VILLAGE OF ARLINGTON HEIGHTS **STAFF DEVELOPMENT** **COMMITTEE REPORT**

File Number: PC 19-001
Project Title: Arlington 425
Address: Campbell/Highland/Chestnut
PIN: Multiple PIN's

To: Plan Commission
Prepared By: Sam Hubbard, Development Planner
Meeting Date: March 27, 2019
Date Prepared: March 22, 2019

APPENDIX 4 – Campbell Building Western Setback Variation: Approximate Location of Campbell Building in Relation to Zoning to the West

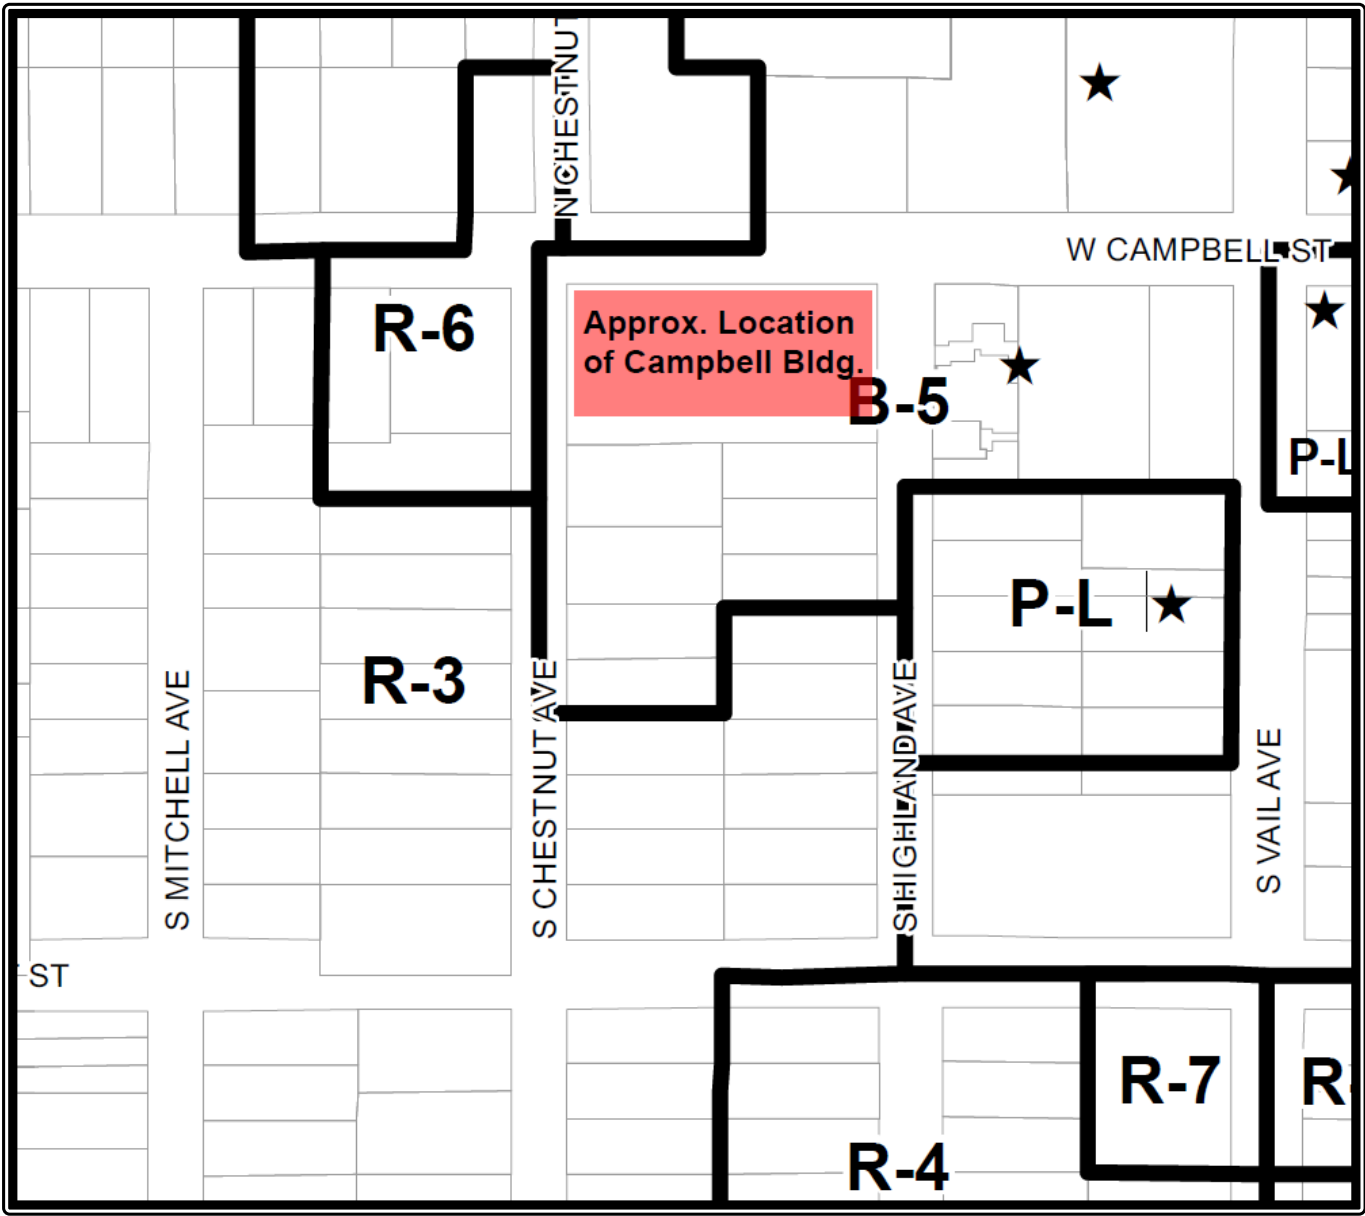
- **Variation to Chapter 28, Section 5.1-14.2a, Required Minimum Yards, to allow a 7' setback along a public street frontage (Chestnut Avenue) for the Campbell building where code requires a 20' setback**

1. The B-5 regulations state that a 20-foot side yard setback is required “where 50% or more of the property directly across the street frontage is zoned R-3”. Since over 50% of the property on the western side of Chestnut is within the R-3 zoning district, the 20-foot setback is required. However, the portion of property directly to the west of the Campbell building is within the R-6 zoning district. Although the strict application of the code requires the 20-foot setback along the entire western side of the site, the property directly adjacent to the Campbell building is not within the R-3 district. **Appendix 4** at the end of this report illustrates this relationship.

2. The property immediately to the west of the proposed Campbell building is currently vacant and owned by the petitioner. One of the purposes of the zoning code is to “protect the stability of the residential, business, and manufacturing areas within the Village and to promote the orderly and beneficial development of such areas. Should the setback variation create a situation that would threaten the essential character of the locality or orderly and beneficial development, it is not likely that the petitioner would propose such a setback, which would have the most impact on property they own directly to the west.

3. The substandard width of Chestnut Avenue is a unique circumstance that requires the dedication of eight feet of land along the western side of the site. Absent this dedication, the extent of the setback variation would be significantly reduced (from a 13-foot variation to a 5-foot variation).
